March 15, 2012

Comments to EPA Region 8 on Draft Federal Implementation Plan for Montana
March 14, 2012

**U.S. Fish and Wildlife Service's Comments on
Best Available Retrofit Technology (BART) for PPL Montana's J. E. Corette
Generating Station (Corette)**

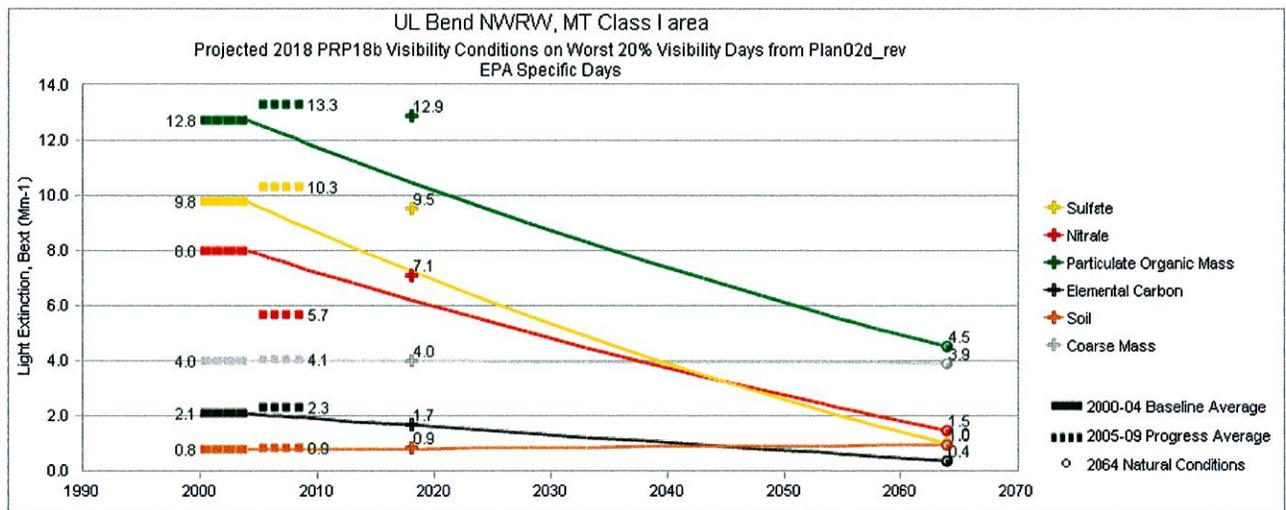
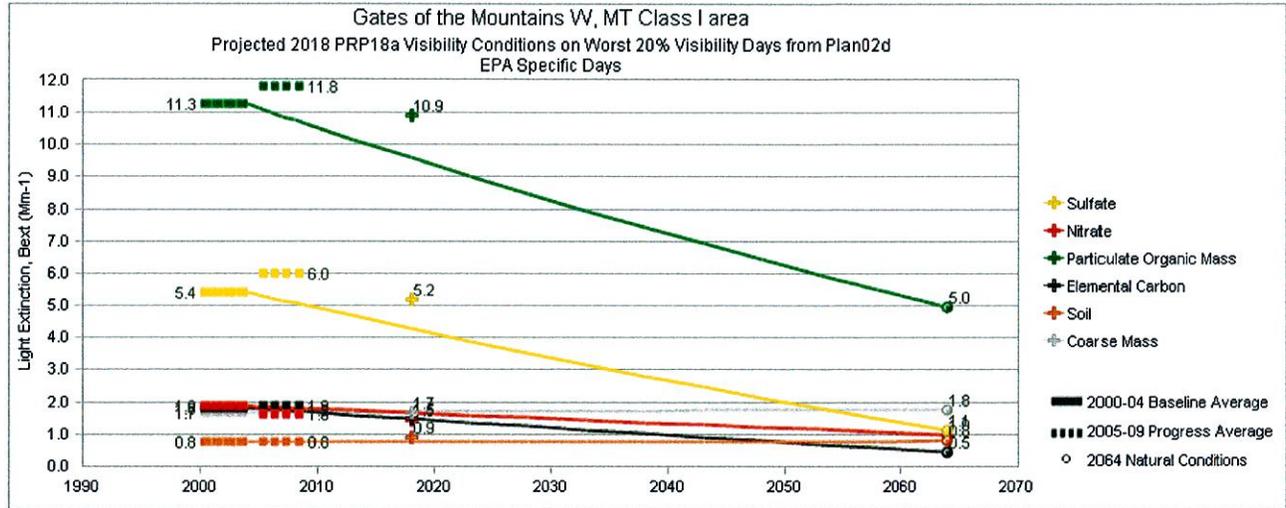
Several western states have used separate glide paths for each visibility impairing pollutant as added weight of evidence to demonstrate that the state is making reasonable progress on the pollutants that are controllable by the states. In the case of Montana, it is hard to make this case when only slight reductions in sulfate are projected by 2018. Results illustrated in enclosed two figures are representative of Montana Class I areas. We would like to discuss this further with EPA.
